IREDELL COUNTY HEALTH DEPARTMENT

IMPROVEMENT PERMIT / AUTHORIZATION TO CONSTRUCT / OPERATION PERMIT / EXISTING SYSTEM INSPECTION

PERMIT# 107014 PIN# 4639 76 8041.1 4639774293 DATE 4/30/03

SUBDIVISION CREEKWOOD BLOCK / SECTION 1 LOT 1 LOT AREA .63AC SITE CLASS. PS DESIGN FLOW 360GPD L.T.A.R. .3000 SQ FT

INITIAL SITE SKETCH

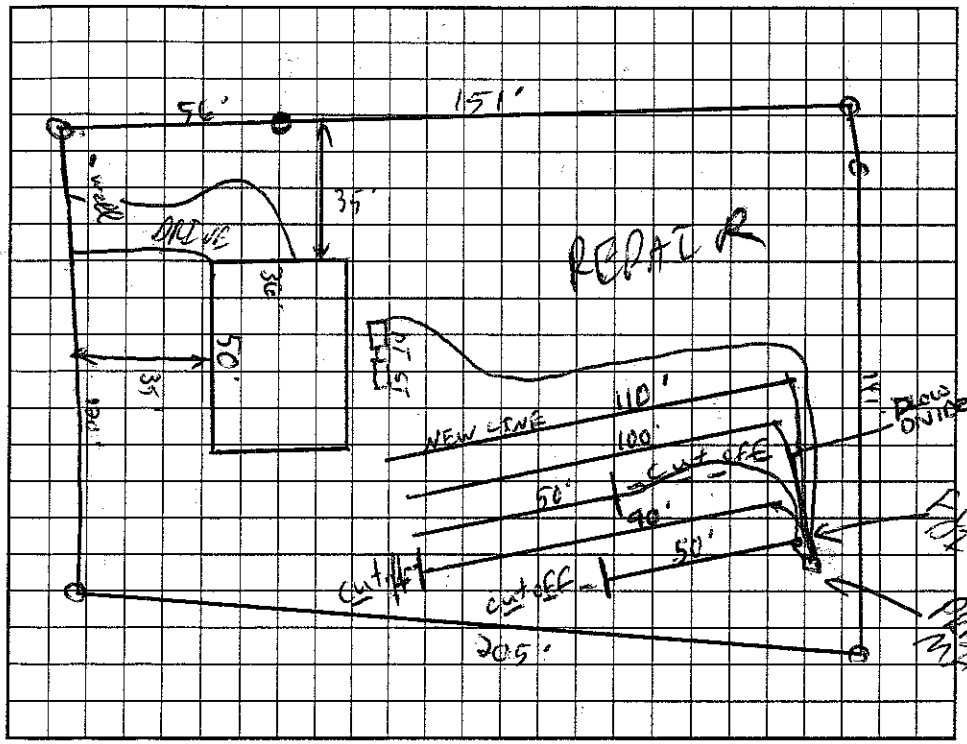
Comments:/Conditions: 1) CUT OFF UPPER LINE AT 50' IN LENGTH. DIG OUT 10' AND TAMP CLEAN SOIL TO CREATE DAM. 2) CUT OFF 3RD EXISTING LINE AT OPPOSITE END AS UPPER LINE AND DO SAME AS UPPER LINE.

Comments:/Conditions: 3) CUT OFF 2nd LINE TO 90' IN LENGTH TO KEEP 10' FROM PROPERTY LINE AND DO SAME AS PREVIOUS LINES. 4) 4 TAPS TO BE INSTALLED WITH FLOW DIVIDER ON THE 2-50' LINES.

5) ~~X~~ FIND END OF EXISTING LINES TO DETERMINE ORIGINAL DISTRIBUTION

6) IF ORIGINAL DISTRIBUTION IS ON OPPOSITE ENDS OF PRESSURE MANIFOLD THE SECOND AND THIRD LINES ARE TO BE ABANDONED AND EXTRA 100' TO BE INSTALLED BELOW NEW 110' LINE.

7) ~~X~~ AFTER FINDING ORIGINAL DISTRIBUTION OF SYSTEM - CONSULT WITH HEALTH DEPARTMENT BEFORE INSTALLATION.

8/21/03 - EZ FLOW INSTALLED - FLOW DIVIDER INSTALLED.
